THE REGIONAL MUNICIPALITY OF YORK

ADDENDUM #10

BID # RFTC-1602-24

FOR: Construction of the Box Grove Community Housing Development - A Four (4) and Six (6) Storey, 153-Unit Building at 15 Vettese Court in the City of Markham

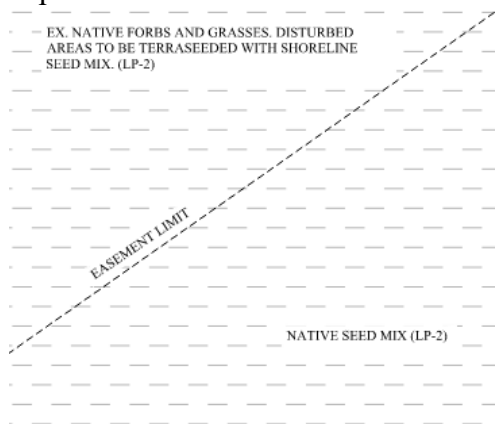
Please locate the Eco blanket on landscaping drawings

The Eco blanket area is labeled on LP-1 as "terraced with shoreline seedmix" and depicted with a dash hatch.

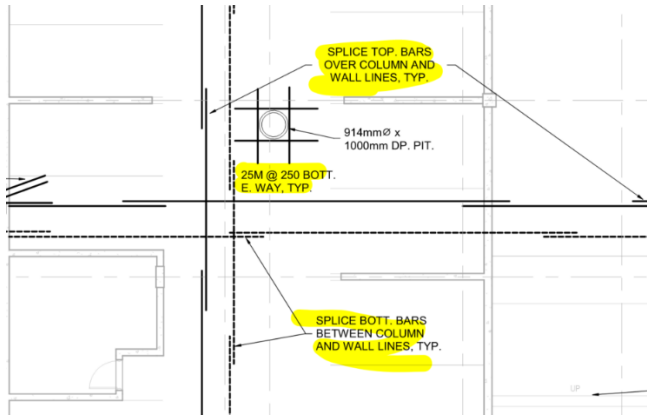
Referring to the subject project, could you please confirm top bars in the Raft slab. Dwg S2.1a

Refer to revised Structural drawings issued with Addendum #8.

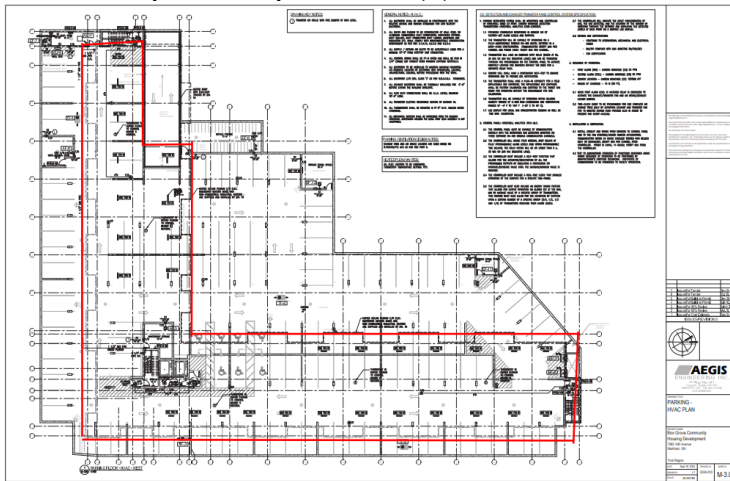
Please provide details for the steel beam with bottom plate shown on Architectural Section 2/A5.04, which is not indicated on the structural drawings. Kindly also provide similar details for the louvers at the garage entrance (gridlines G/16–17).

Refer to response to question #9(1) from addendum #8
